Re: Helix Micro Rebar Shop Drawings  
405 SE Weiss Cir  
Lot 176, Mill Creek  
Lee's Summit Permit #2017-1816

Apex Engineers, Inc. observed the plans for the proposed house at the address referenced above. The plans were evaluated for substituting Helix micro rebar for the foundation reinforcing steel. The recommendations and attached detail sheets shall be considered shop drawings for an alternative reinforcement design.

# ALTERNATE REINFORCEMENT DESIGN/HELIX MICRO REBAR

5 COLUMN PAD DETAIL  
H2.0 / X=1'-0"

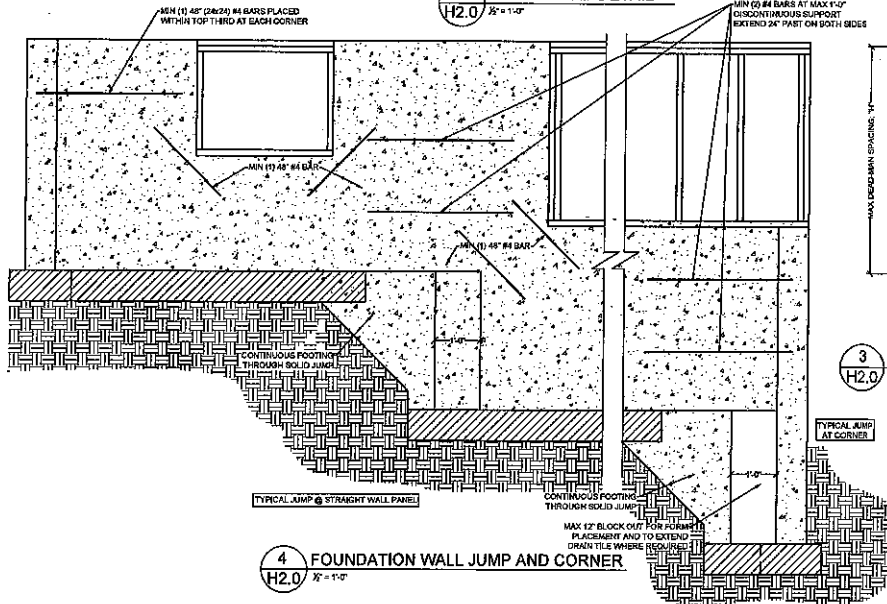
- Details 4/H2.0 & 5/H2.0 – Install corner reinforcing and column pads reinforcing per the attached details.
